APPLICANT(S): BEHAR, Vered et al.  
SERIAL NO.: 10/516,411  
FILED: December 2, 2004  
Page 18

### **AMENDMENTS TO THE DRAWINGS**

## REMARKS

FIG. 86B

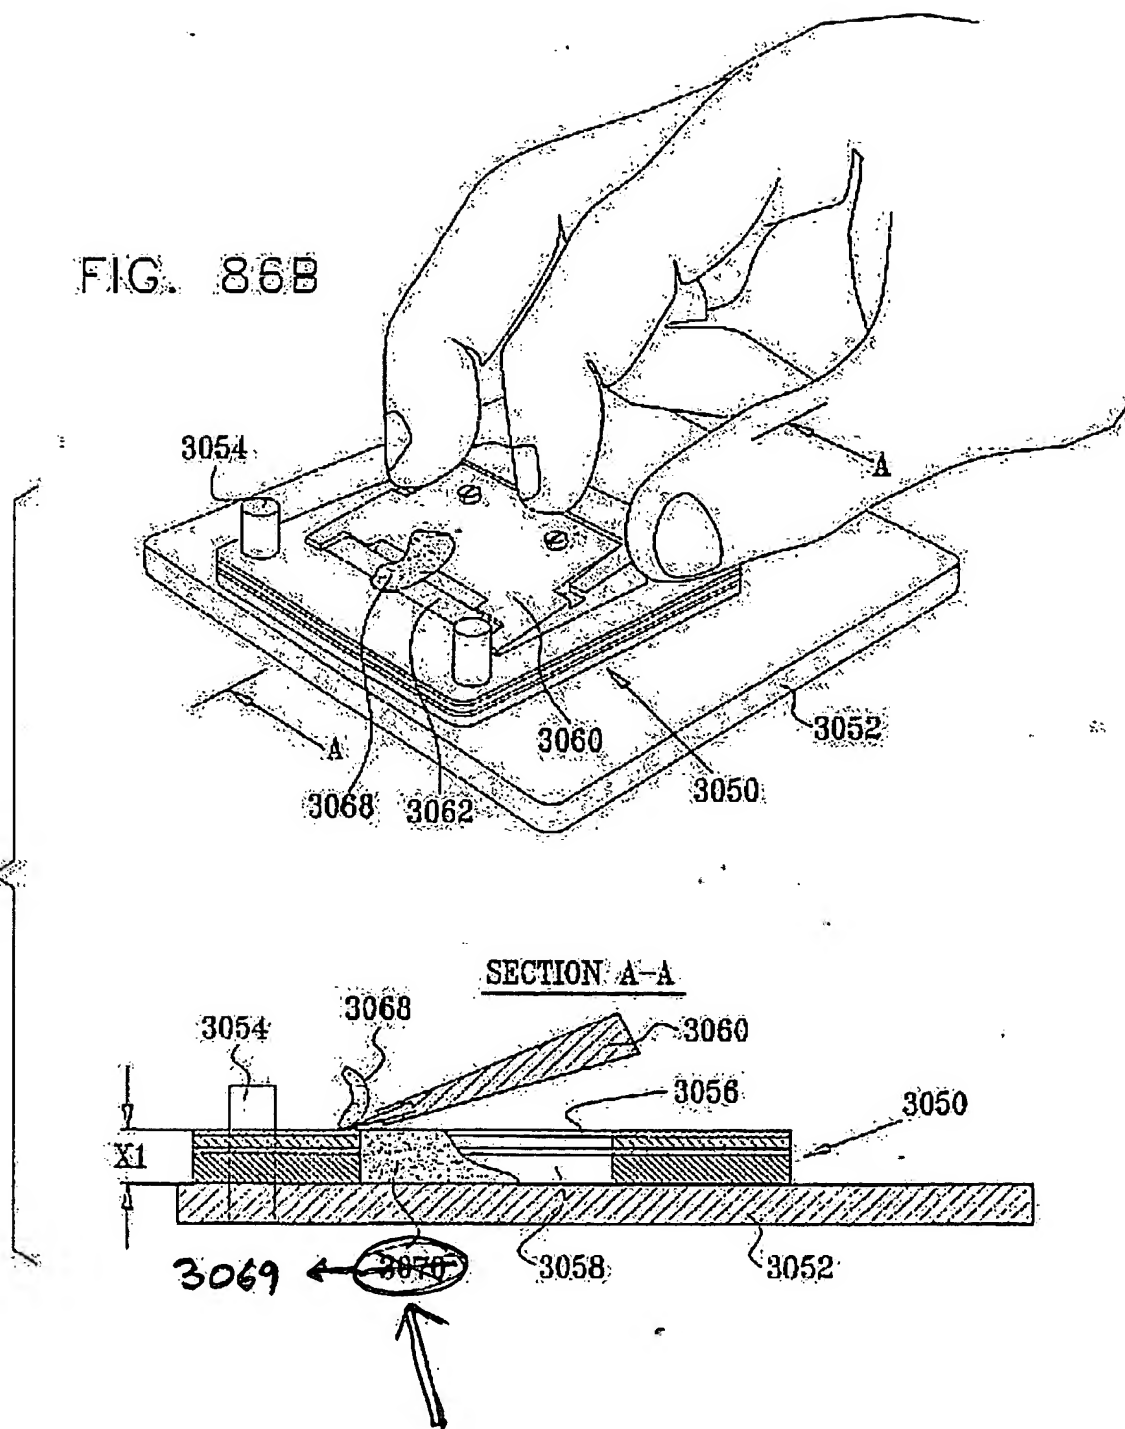
In the paragraph beginning on page 91, line 4, the reference numeral “3070” is replaced with the reference numeral “3069” throughout the paragraph, in order to clearly distinguish the bottom portion 3069 of amended Fig. 86B from the plurality of slabs 3070 of Fig. 87A.

In Amended Fig. 86B the reference numeral "3070" is replaced with the reference numeral "3069" to make Fig. 86B conform with the Amended specification.
